Ref: C3388
29 September 2026

Re: Engineers Comments Regarding Surface Water Drainage- The Grange, Westergate Street, PO20 3SQ. Removal of mobile home and replacement with 1 No. self-build dwelling and associated works. This application is in CIL Zone 1 (Zero Rated)

Application reference: AL/52/26/PL

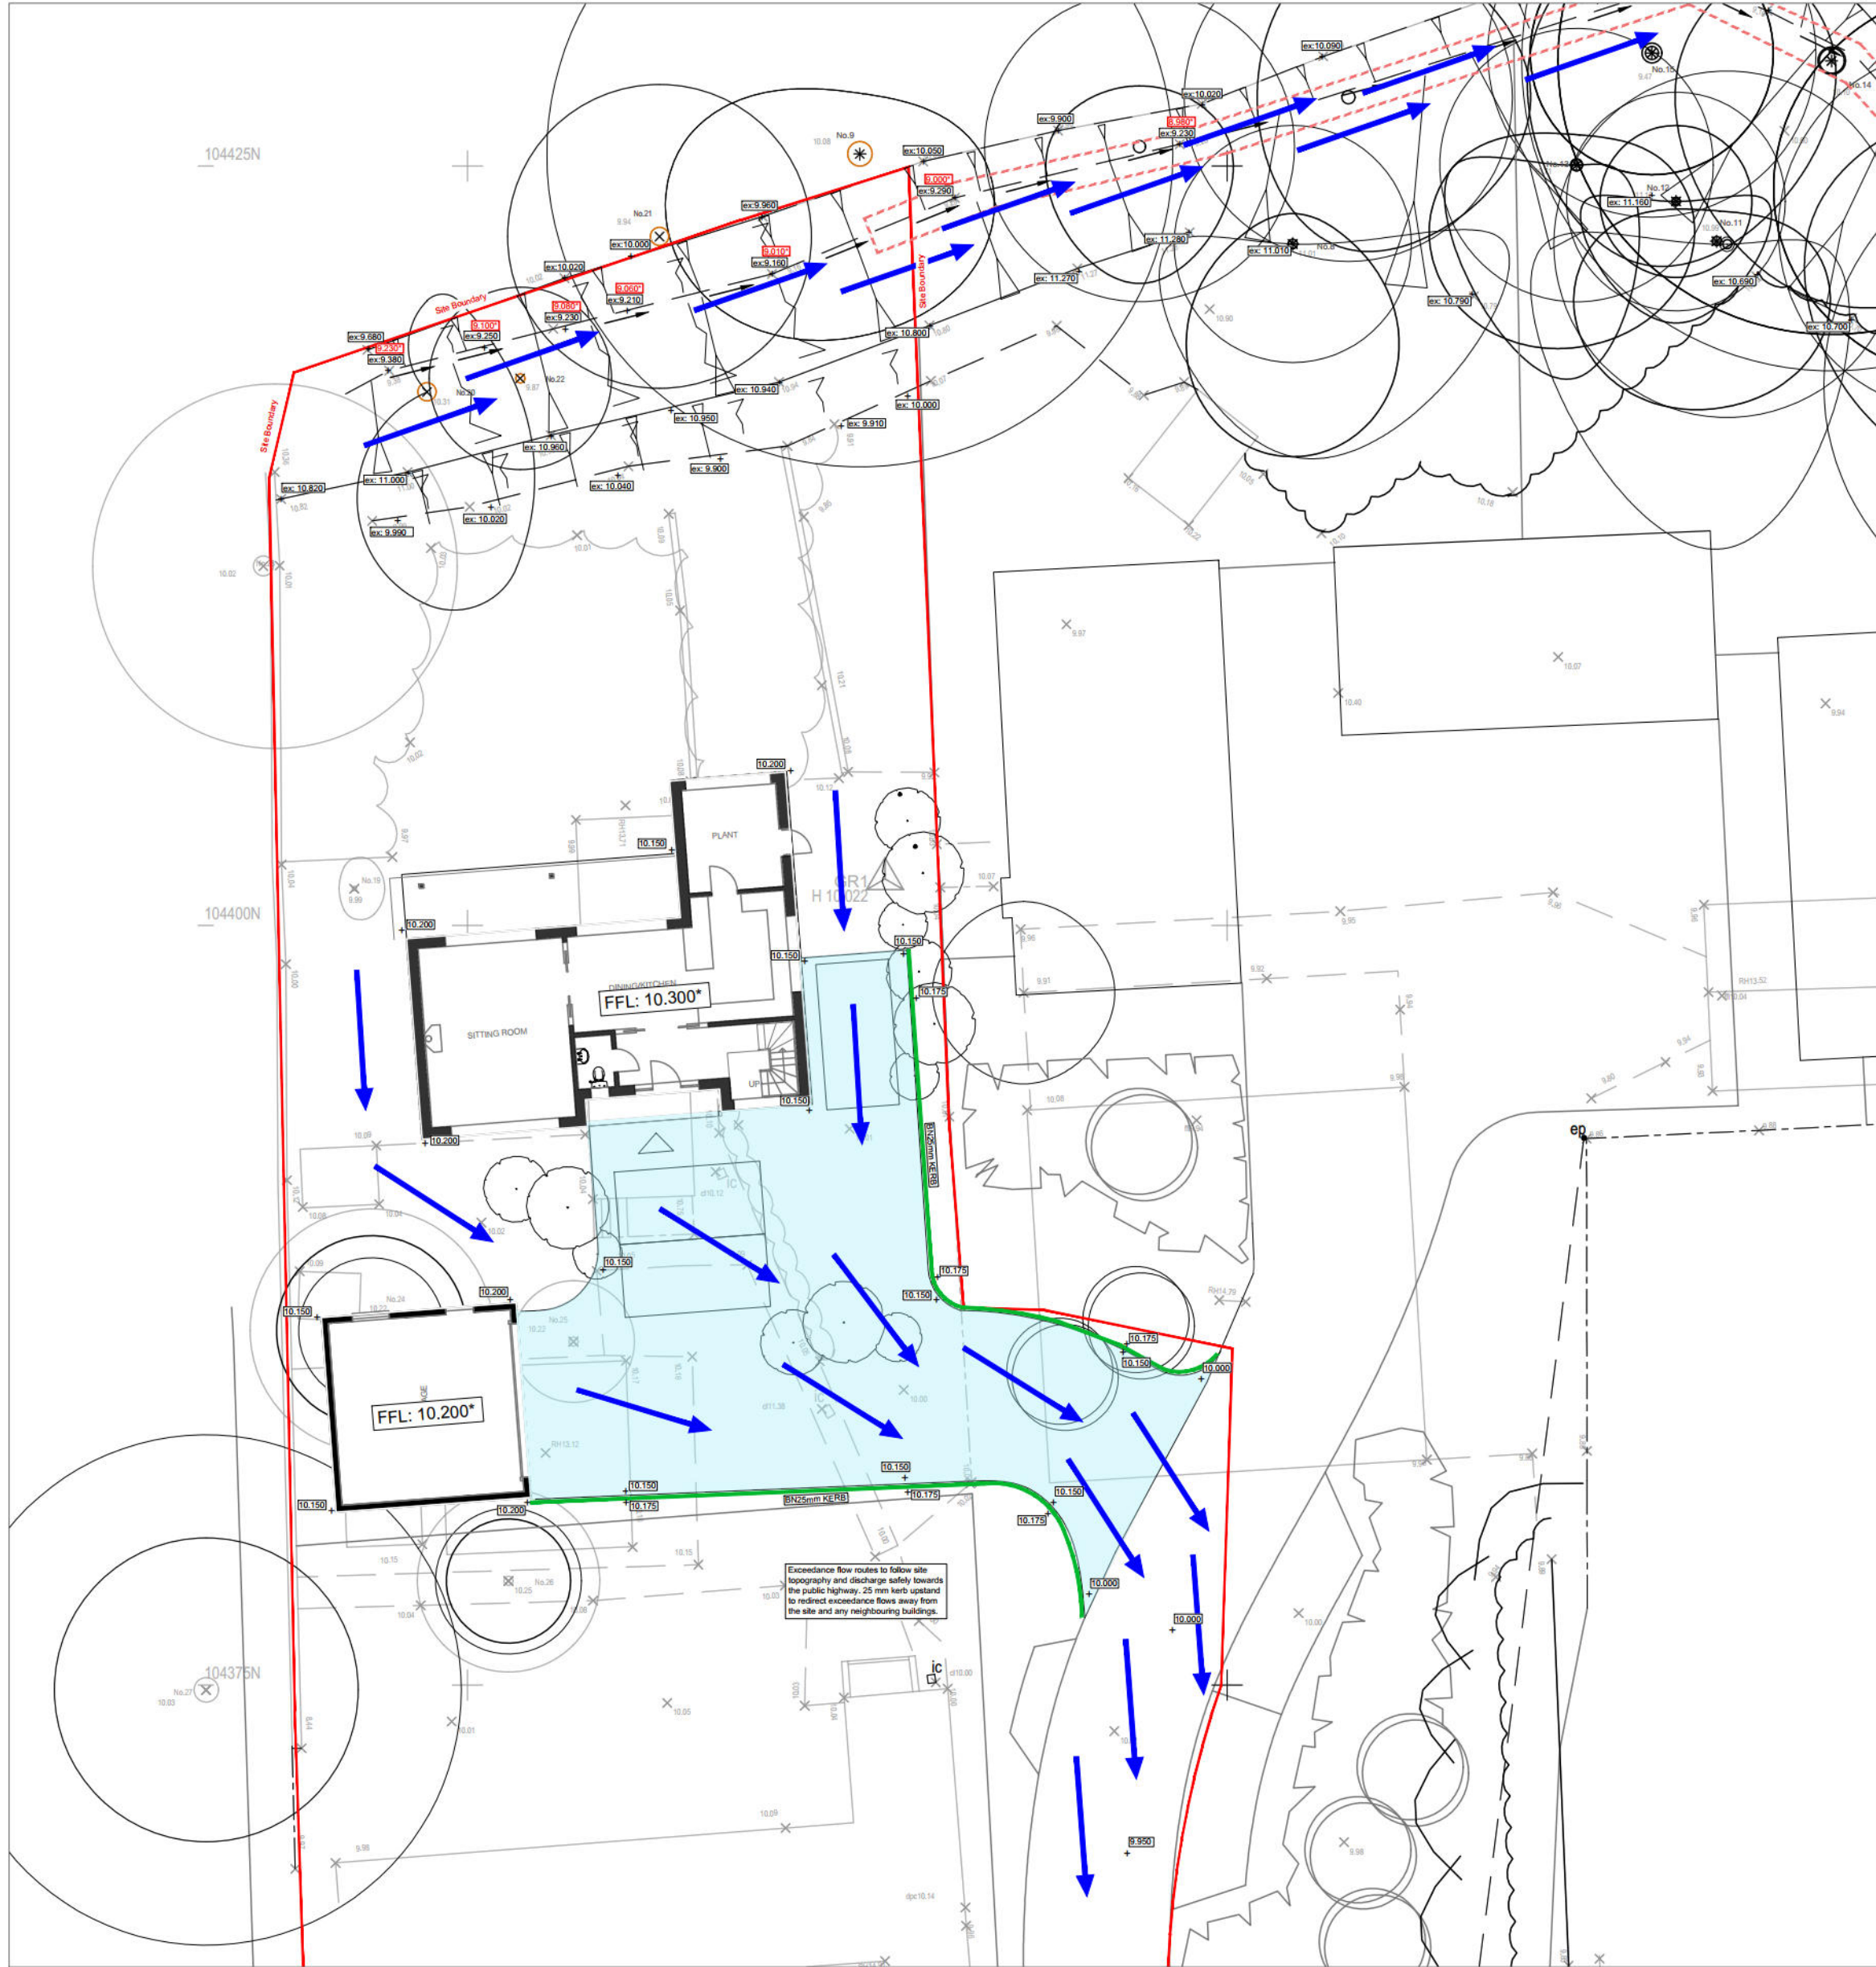
3.3. The design to manage extreme rainfall is not currently demonstrated to be in accordance with the requirements of NSfS Standard 3. Therefore, we object to the application.

With regard to LLFA Comment 3.3, the exceedance flow routes have been specifically designed to follow the existing and proposed site topography, providing defined overland flow routes away from the proposed buildings and other vulnerable areas. Please refer to Drawing No. 201.

The exceedance routes generally follow the available site levels and are directed towards the public highway to the south, providing a defined route for surface water should the drainage system be exceeded during an extreme rainfall event.

In addition, a 25 mm BN kerb upstand has been incorporated at the driveway to provide positive guidance for overland flows and safely redirect them towards the public highway.
